# Memorandum to the City of Markham Committee of Adjustment

**File:** B/022/20  
**Address:** 5 Lunar Crescent – Markham, ON  
**Applicant:** Hong Lin Wang  
**Agent:** Z Square Group  
**Hearing Date:** May 5, 2021

The following comments are provided on behalf of the Central Team. The purpose of this application is to create one new residential lot. The applicant is requesting provisional consent to:

SITE PLAN  
**A1.1**

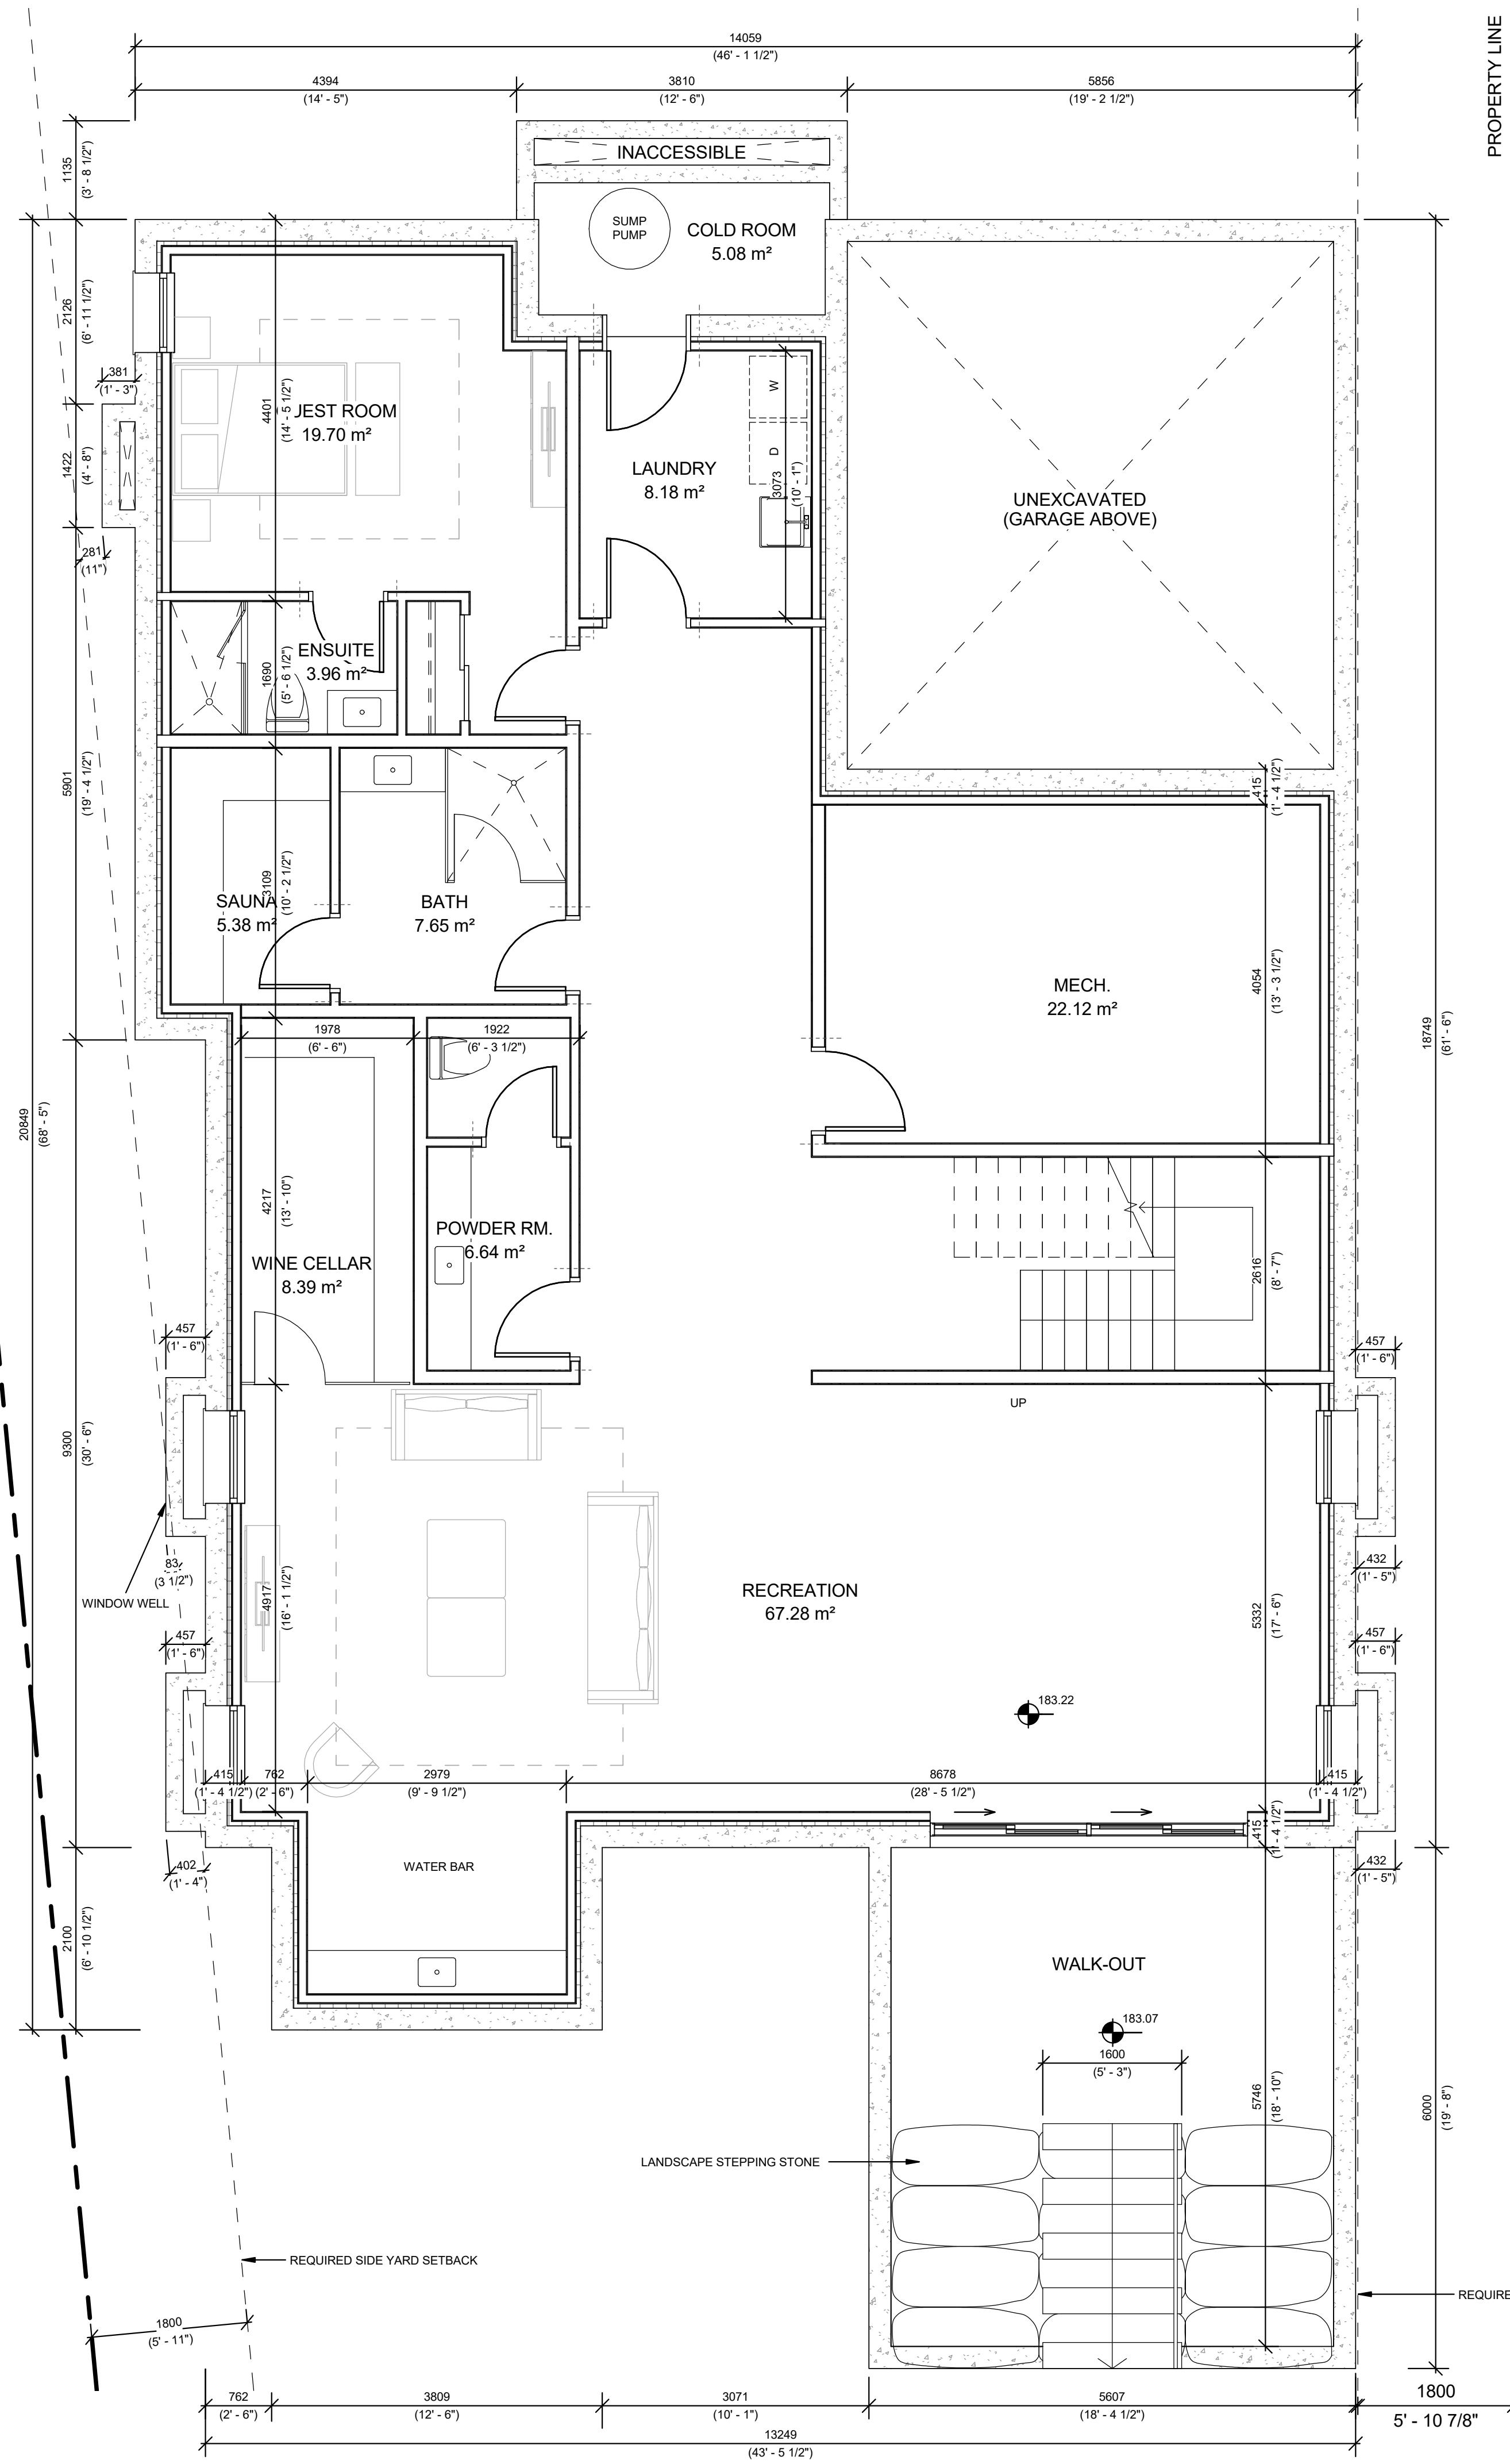
The applicant submitted a completed ZPR which confirmed the need to obtain a variance to the By-law related to an increase in lot coverage for the proposed development. However, the applicant submitted revised drawings and plans as part of their formal submission which complies with the minimum lot coverage as permitted by the By-law (Appendix “D”).

The applicant made further revisions to the drawings after receiving staff comments relating to the preservation of a mature tree (Tree #1) located in the front yard (see Tree Protection Plan in Appendix “E”). The applicant completed a new ZPR, and received a

TREE PROTECTION /REPLANTING PLAN

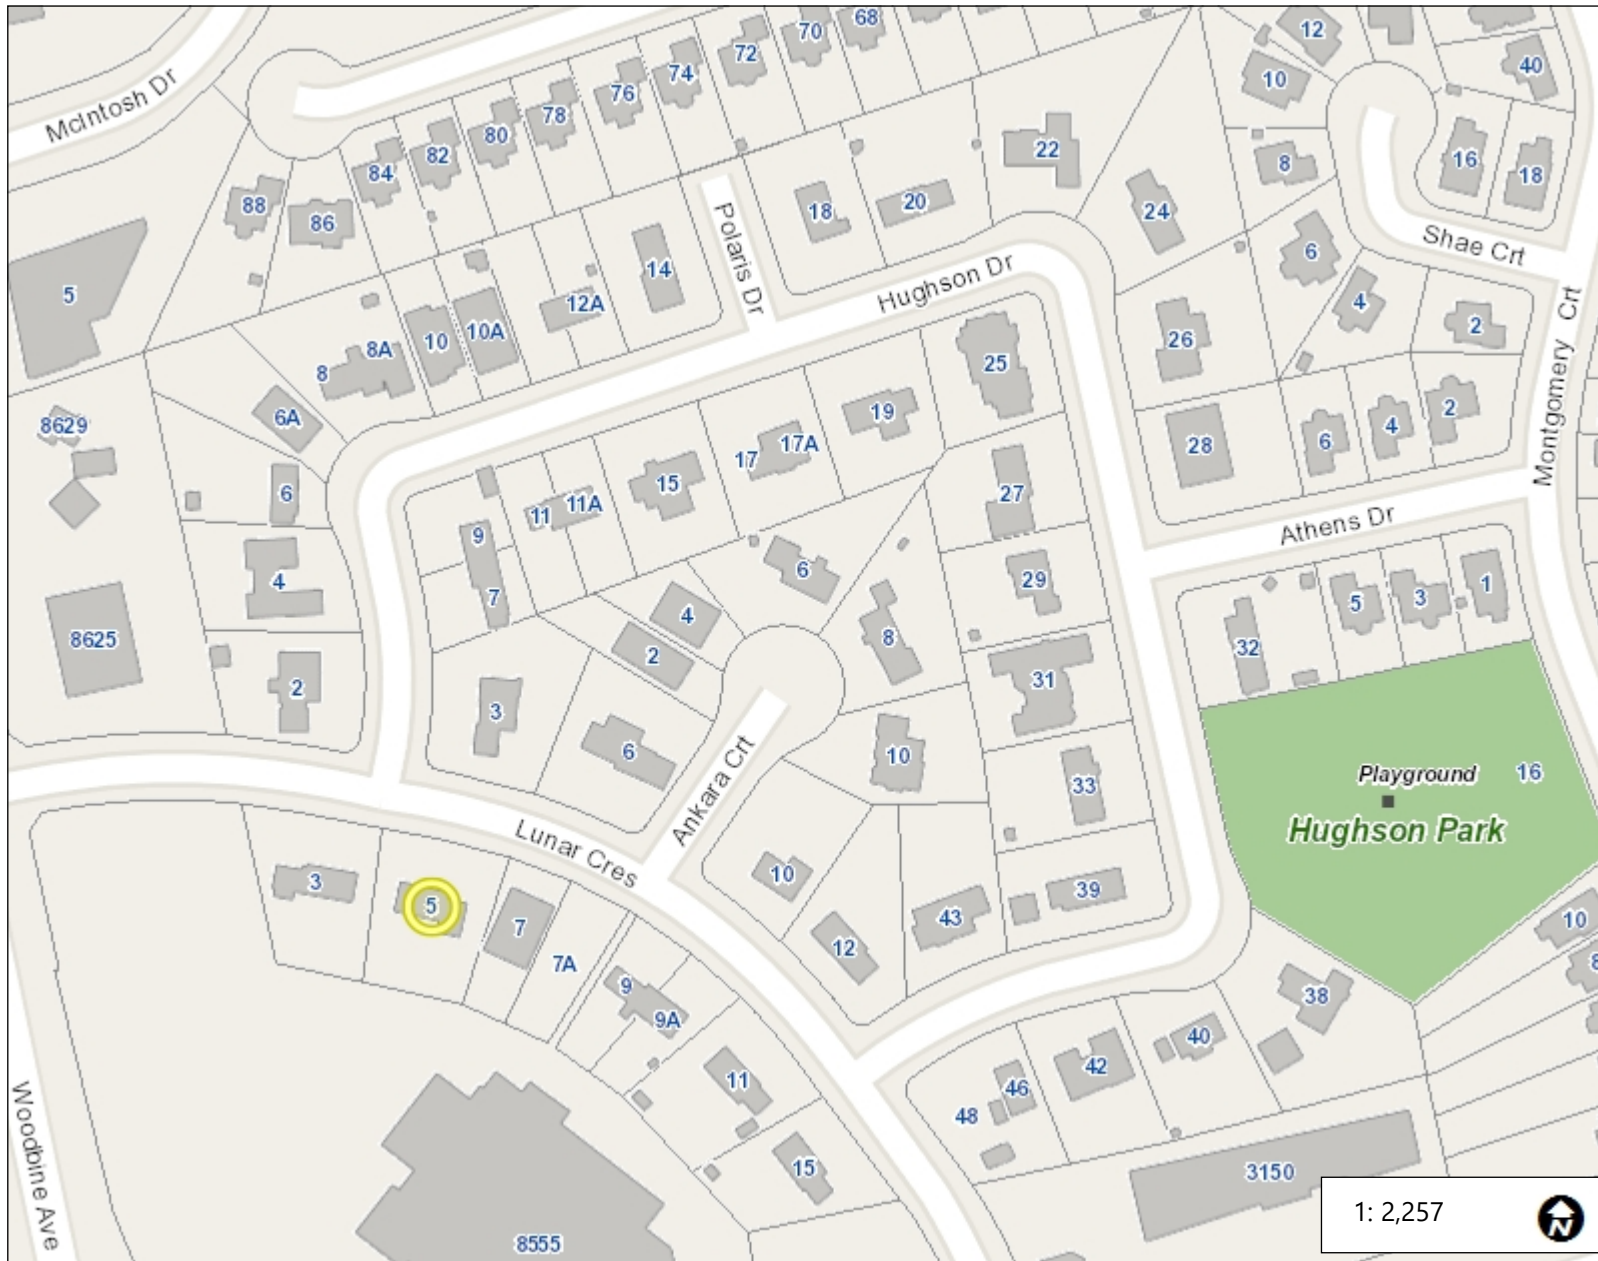
Urban Design staff reviewed the application, and recommended that the applicant flip the driveway on the retained lot (Part 1), to preserve Tree #1 as identified in the Tree Protection and Replanting Plan. Tree #1 is a mature Alaskan Cedar tree in fair health, located in the front yard, and has trunks with diameters at breast height (DBH) of 0.28 m (0.92 ft) and 0.13 m (0.43 ft).

The applicant has worked constructively with staff to preserve Tree #1, in addition to other trees proposed to be preserved on the subject property (see revised Tree Protection and Replanting Plan in Appendix “E”).

The arborist report and tree protection and replanting plan confirms that a total of 11 privately owned trees exist on the subject property (Appendix “E”). The applicant is proposing to remove seven trees, and protect the remaining four trees as a result of the proposed infill development. The tree protection plan confirms that neighbouring trees will be protected.
